SUBJECT: REQUEST FOR ADDITIONAL INFORMATION (RAI) REGARDING THE SIMPLIFIED  
BOILING WATER REACTOR (SBWR) DESIGN

REQUEST FOR ADDITIONAL INFORMATION (RAI) ON THE  
SIMPLIFIED BOILING WATER REACTOR (SBWR) DESIGN

Purdue University Questions - Set 4

Fig. 2-2. Internal steam separator.  
(Lahay & Moody, The Thermal-Hydraulics of a BWR)

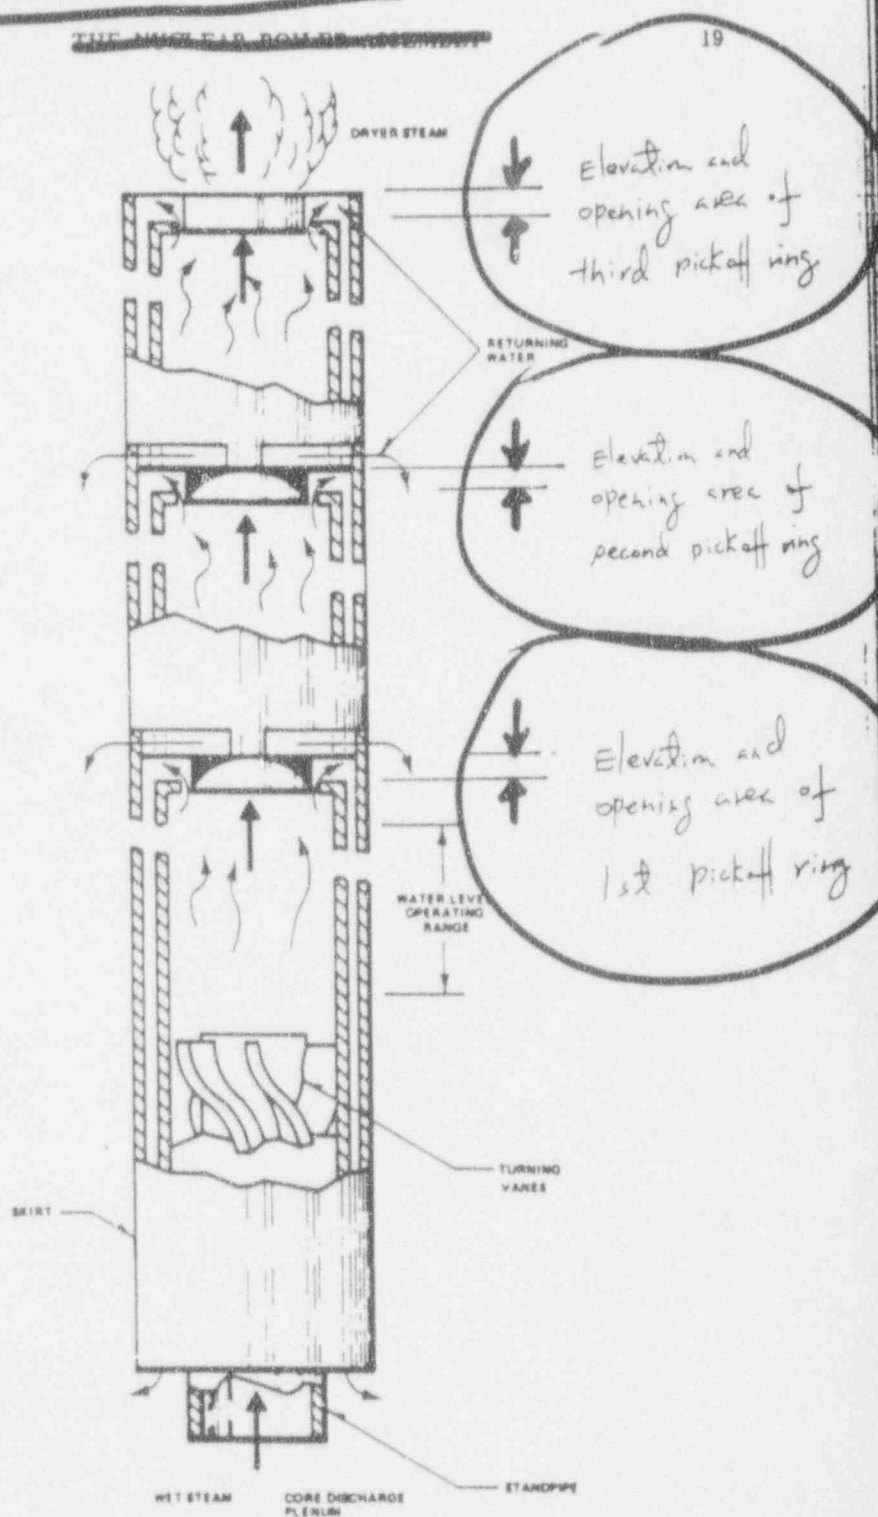
1. Provide the dimensions for the inside diameter and the outside diameter of a steam separator and stand pipe (below the separator) in vessel.
2. Provide the elevation and opening area of the pick-off rings in the steam separator where water from the pool surrounding the separators can drain back into the chimney region, as shown in attached Figures 2-2 and 2.1-16. Indicate which of the two designs shown in these figures represents the SBWR design. How many stages of separation are in a steam separator for the SBWR? If neither of these designs is applicable to the SBWR, provide a drawing of the SBWR design and list the elevation and opening area of the pick-off rings.

Question 2 - Is this design for SBWR?

FIGURE 2.1-16 Steam Separator

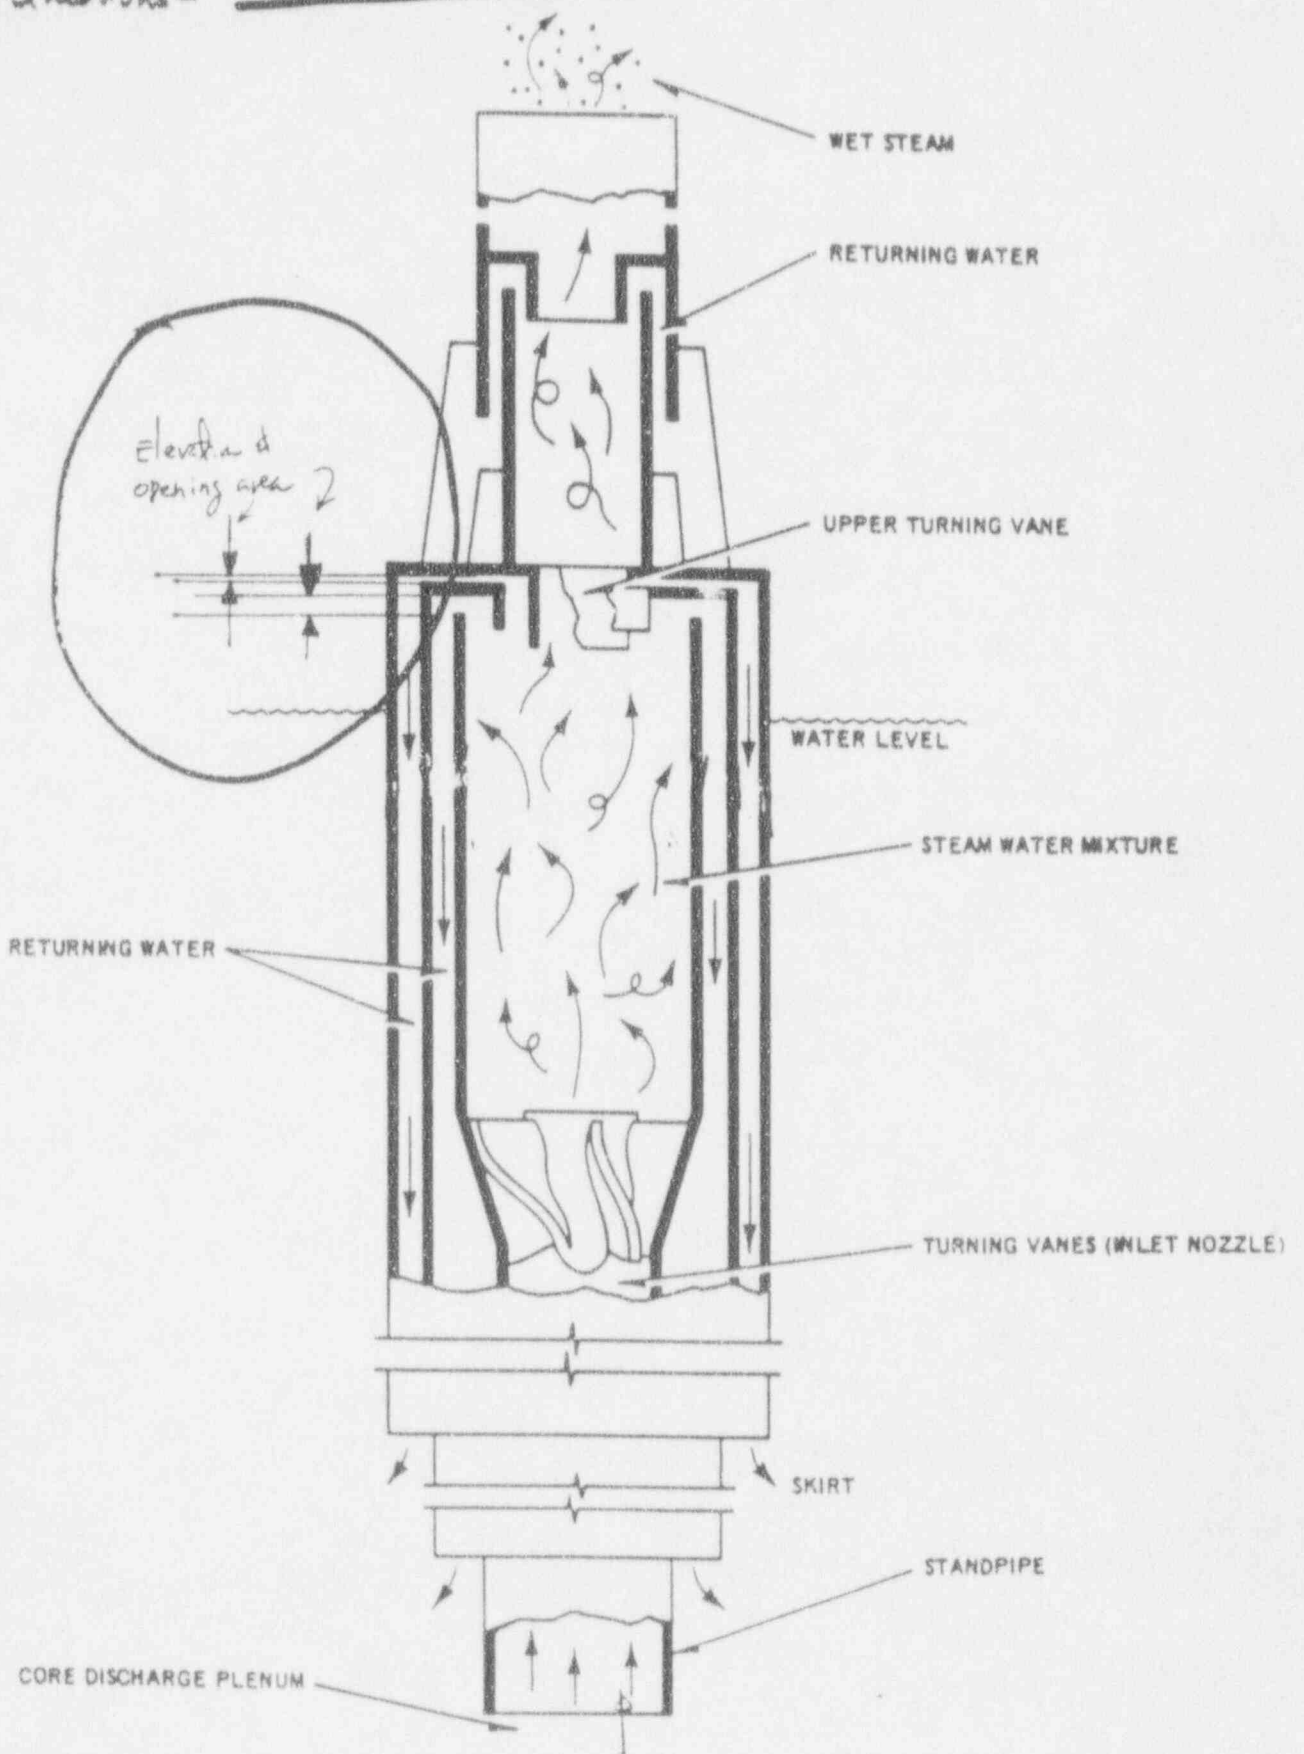
- Is this design for SBWR?

Figure 5.3-3 Reactor Pressure Vessel System Key Features

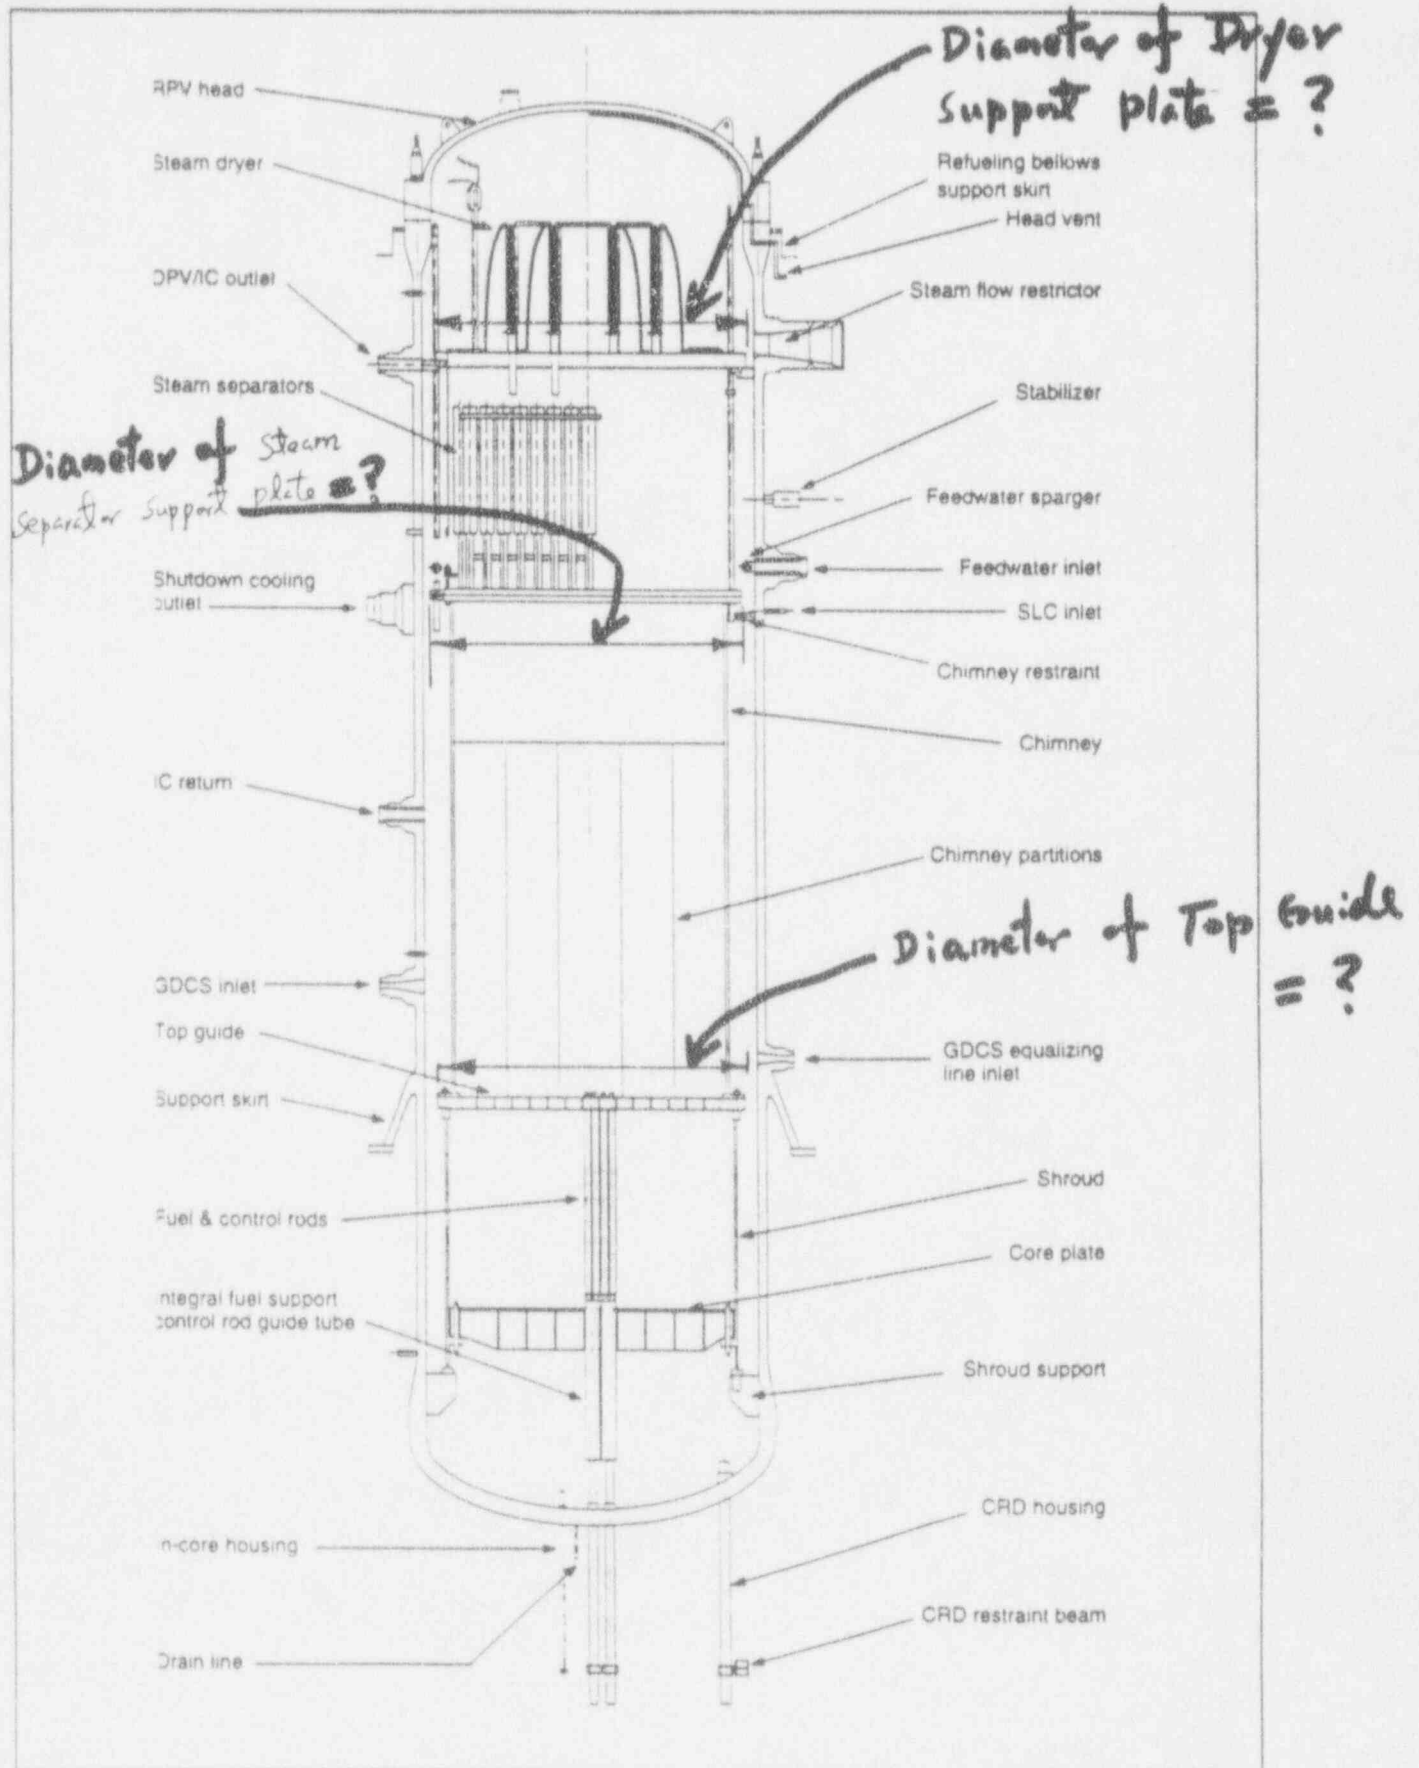
10. Referring to attached Figure 5.3-3, provide the following:
    - a. Diameter of core top guide plate (between the top of the active fuel and the chimney)

- b. Diameter of the steam separator support plate (between the steam separator assembly and top of the chimney)
    - c. Diameter of the steam dryer support plate.

FIGURE 3. LOWER DRYWELL CONFIGURATION

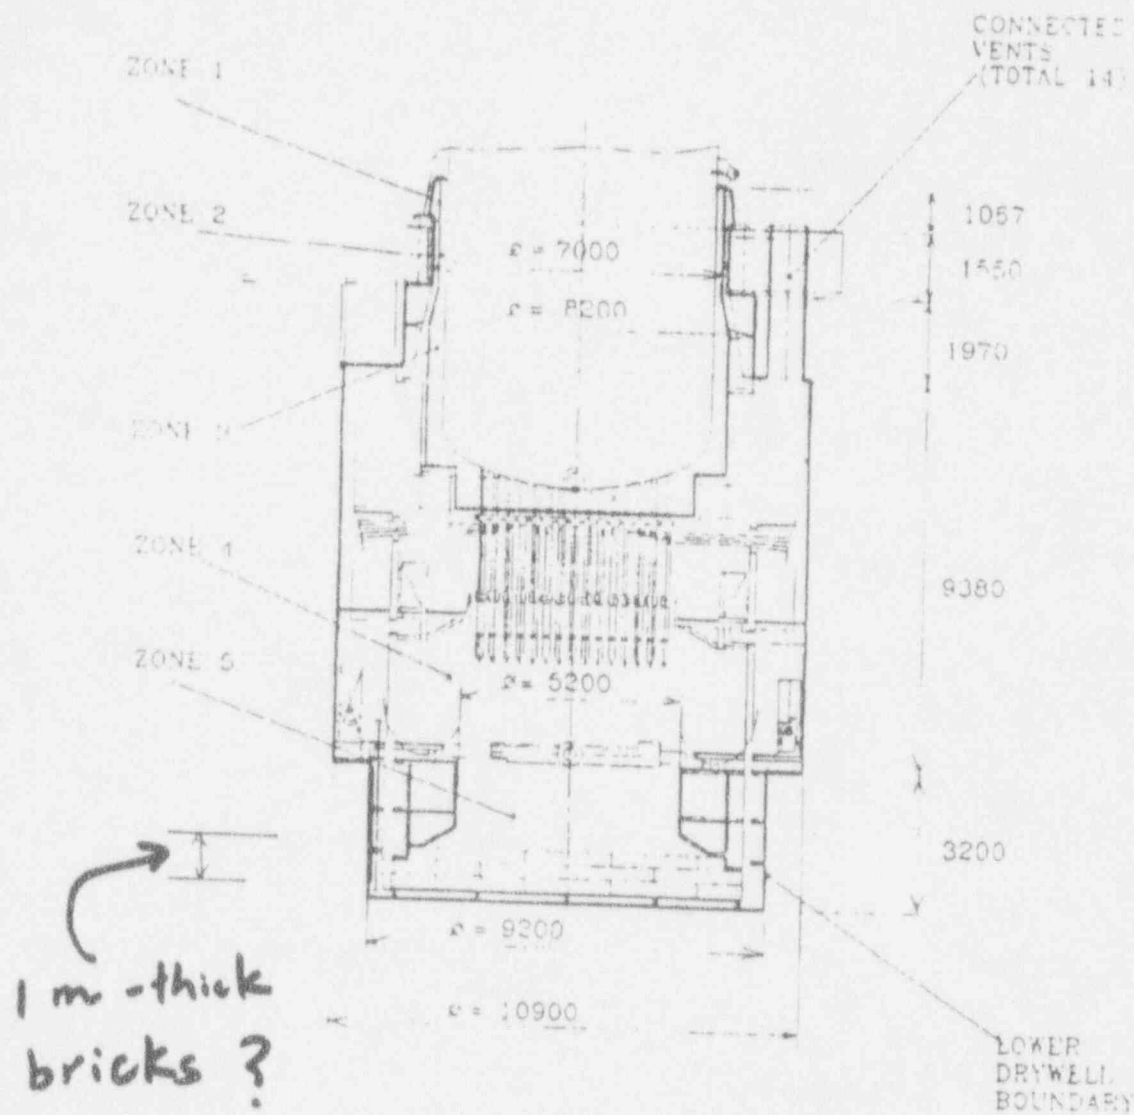
15. Provide free volume as a function of elevation in the lower drywell. The attached Figure 3 (taken from "Design Specification, FMF SBWR, MPL Item No. All-5299, Preliminary Issue DMH-4126 February 12, 1991") suggests that there is a brick layer of about 1 m in thickness at the bottom of the lower drywell which precludes water from filling that location. Does this 1-meter-thick brick layer exist?
